RECORD DWGS  
AS FABRICATED

TOWN OF WARREN, VT  
COUNTY OF WASHINGTON  
BRIDGE NO.173 REPLACEMENT  
WARREN, VT

DESIGN: SAF	DRAW: TLB	REVIEW: SAF/RLL	CHECK: C/JG	ITEM NO.:
				PROJECT NO.: BRF 013-4 (14)
				REFERENCE NO.:
				BRIDGE NO.: 173
				STRUCTURAL FILE NO.:

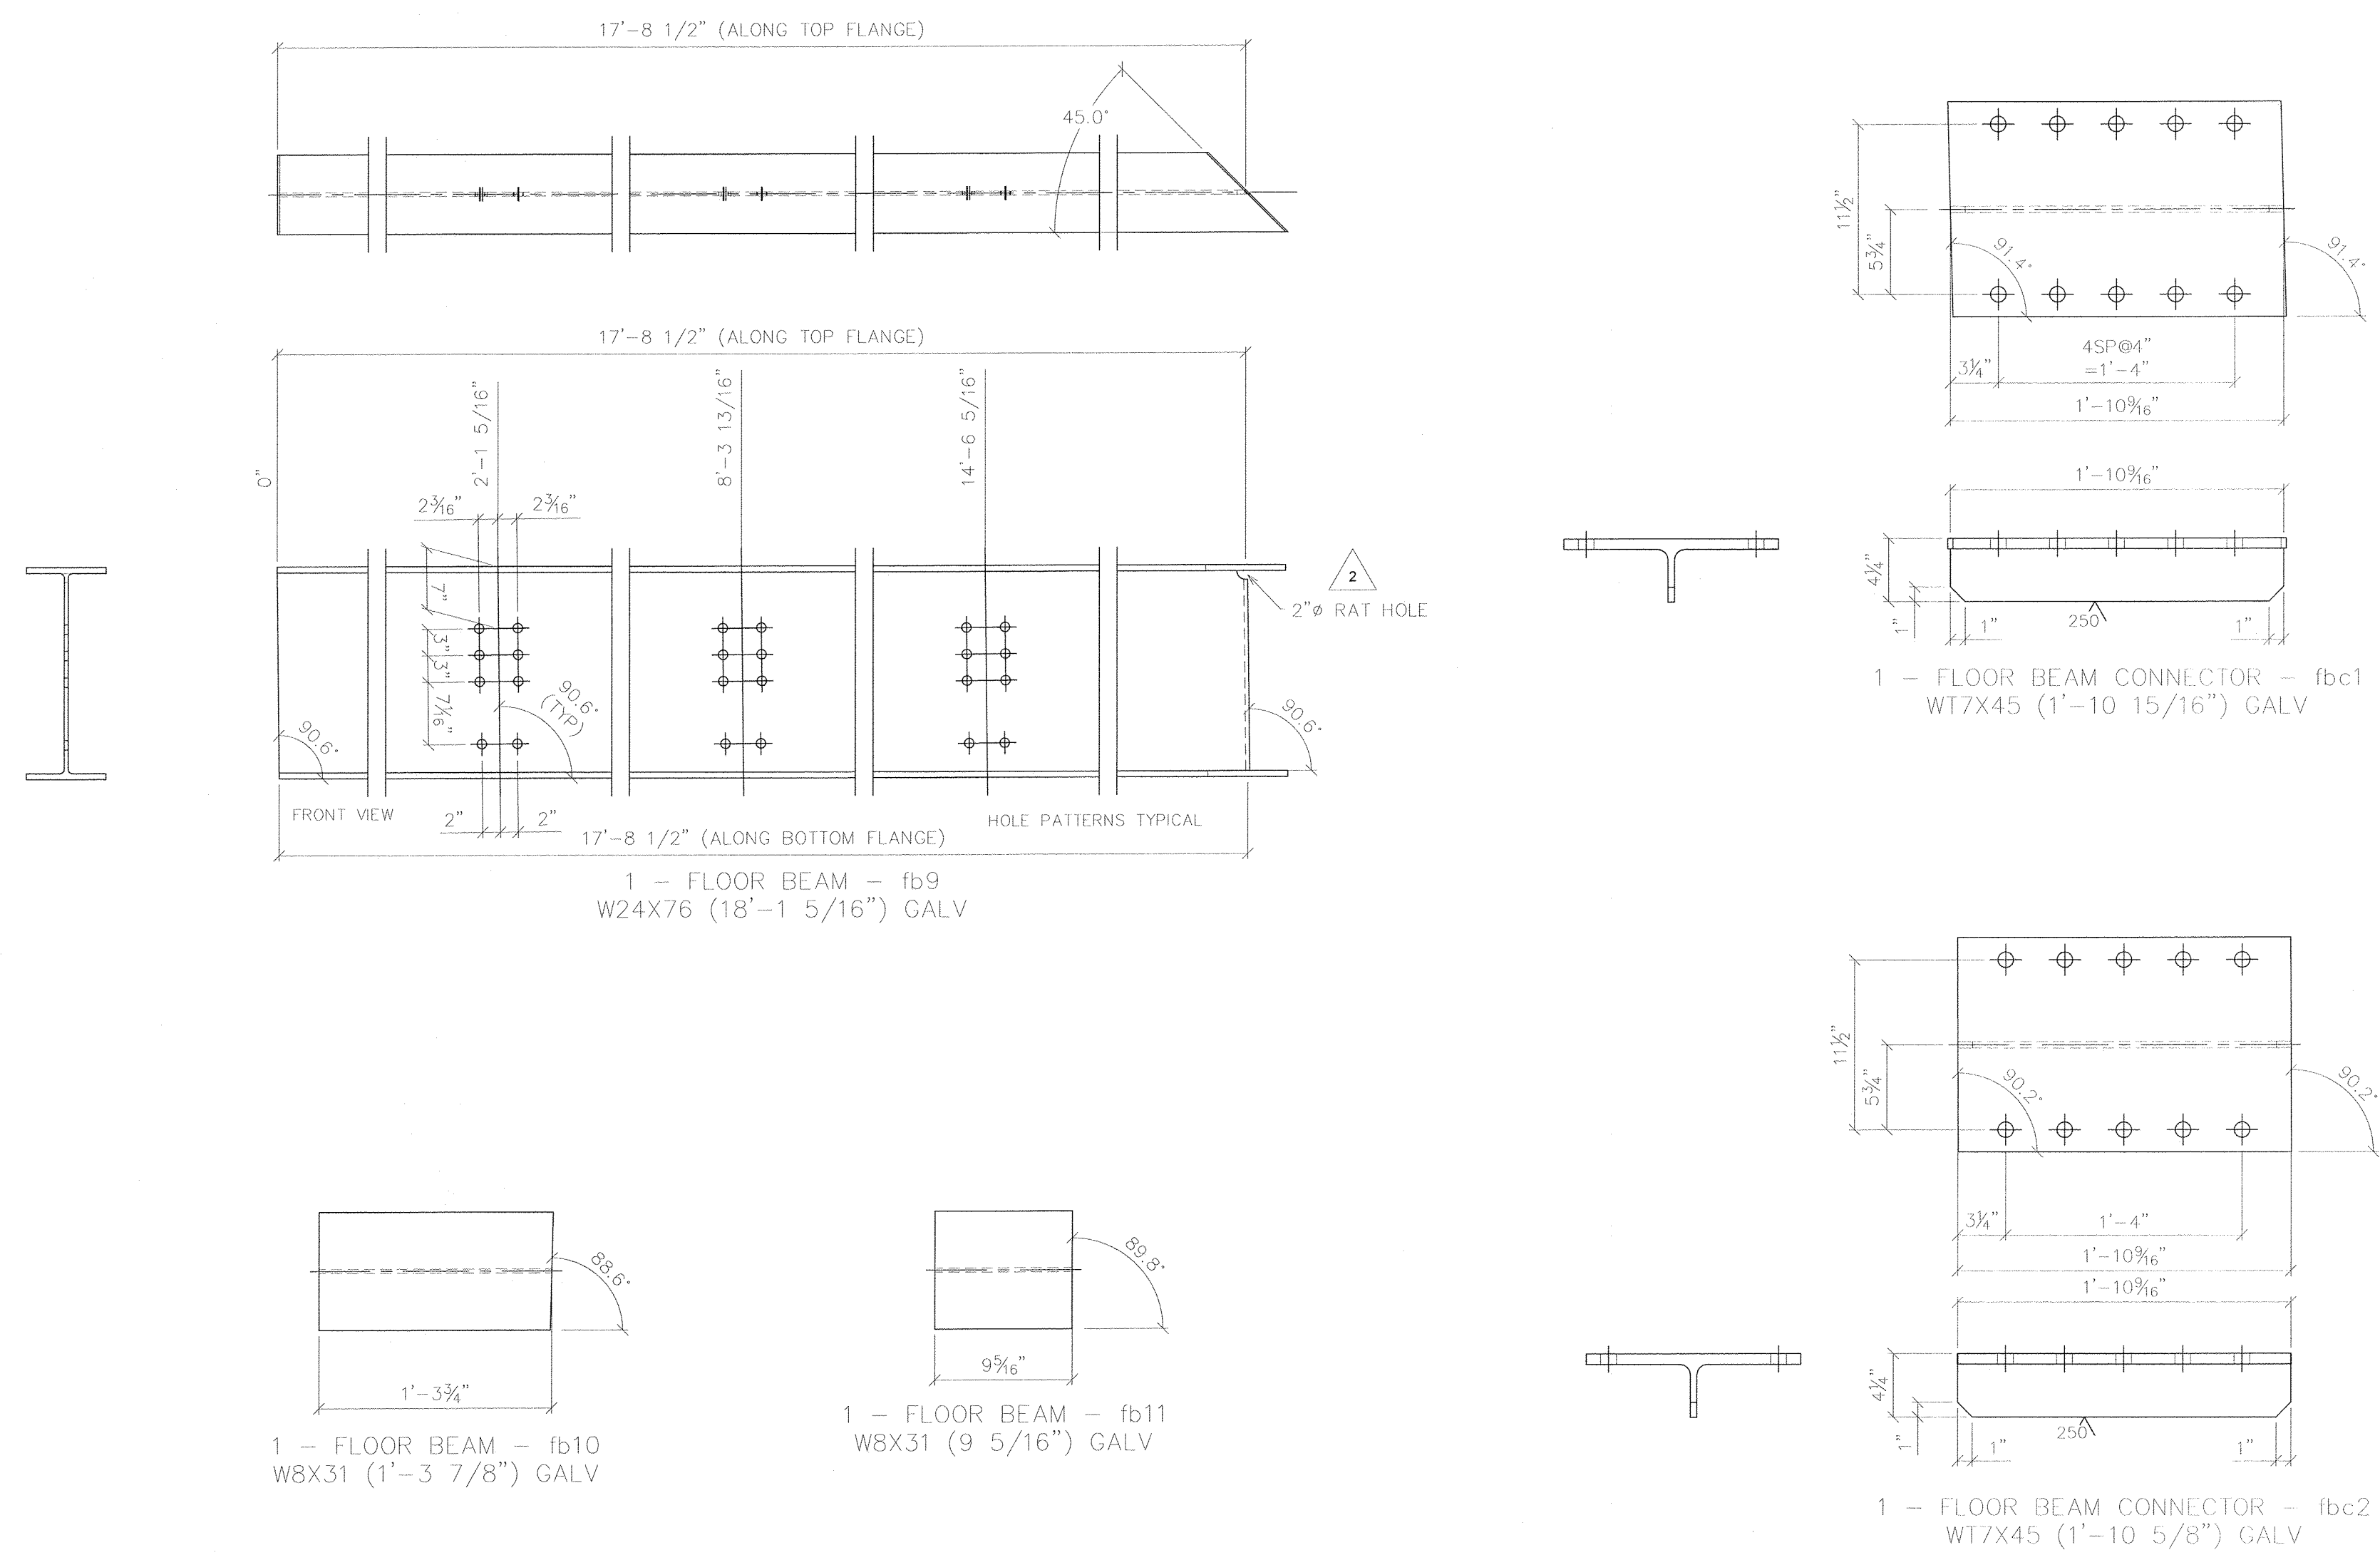
SUBMITTAL LOG	DATE	NO.	DATE	REVISIONS	BY:
INITIAL SUBMITTAL	12/18/12	1	5/15/13	FLOOR BEAM END PLATES WAS 1" THK	TLB
RESUBMITTAL NO. 2	2/5/13	2	5/15/13	ADDED 2" DIA. RAT HOLES IN fb1 & fb9	TLB
CUSTOMER APPROVAL	2/13/13	3	5/15/13	CHANGED WELD WAS 5/8" ALL AROUND	TLB
SHOP REVIEW	-	4	5/15/13	CHANGED BOLT PATTERN	TLB
PRE FAB MTG	-	5	5/15/13	WAS 2" EDGE DISTANCE	TLB
APPROVED FOR FAB	2/28/13	6	6/3/13	DIMENSIONAL ERRORS	TLB
